**SECTION 38 (1) PLANNING (LISTED BUILDINGS AND CONSERVATION AREAS) ACT 1990**

**LISTED BUILDING ENFORCEMENT NOTICE**

Land at 1-3 Bethlehem Street, Grimsby, North East Lincolnshire, DN31 1JN, (“the building”) shown edged in red on the attached plan.

Photo 1 – Showing lights 1 – 6 on Wellowgate

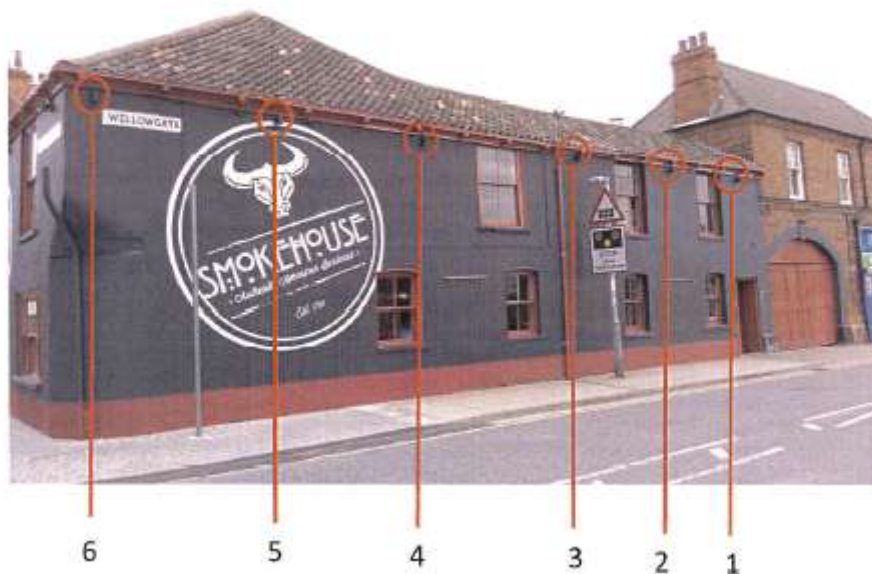
- 3.3    The re-painting of the rendered plinth in red from black (Photo 7).
- 3.4    The addition of 12 exterior down lights and associated wiring (see Photos 1 and 2).

5.1 Remove all 12 external lights (see Photo 1 and Photo 2), their fittings and electricity supply (using a competent and approved electrician).

Photo10 – Showing incorrect facing incl  
incorrect facing spindles

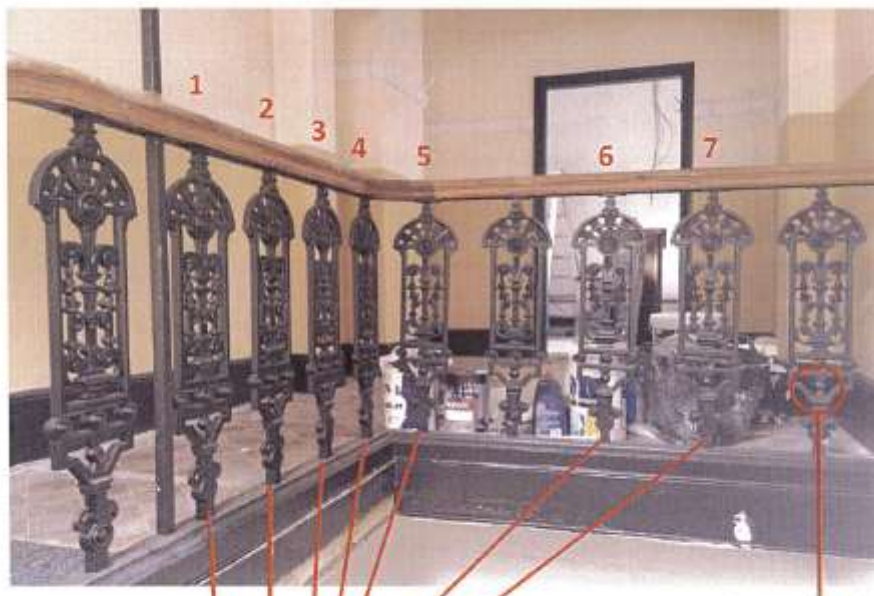
- 3.7    The addition of a chrome cased advertisement to the right of the main entrance door which houses the restaurant menu (see Photo 5).
- 3.8    The disassembly of the main staircase spindles and banister and its incorrect reassembly leading to 7 of its spindles being

replaced incorrectly (see Photo 10) and 1 being missing (see Photo 8).

- 5.11 Carefully remove the 7 spindles which are orientated incorrectly (see Photo 10) making sure the banister and footplate is not damaged. Replace these spindles so that they match the remaining spindles (see Photo 9) in orientation.
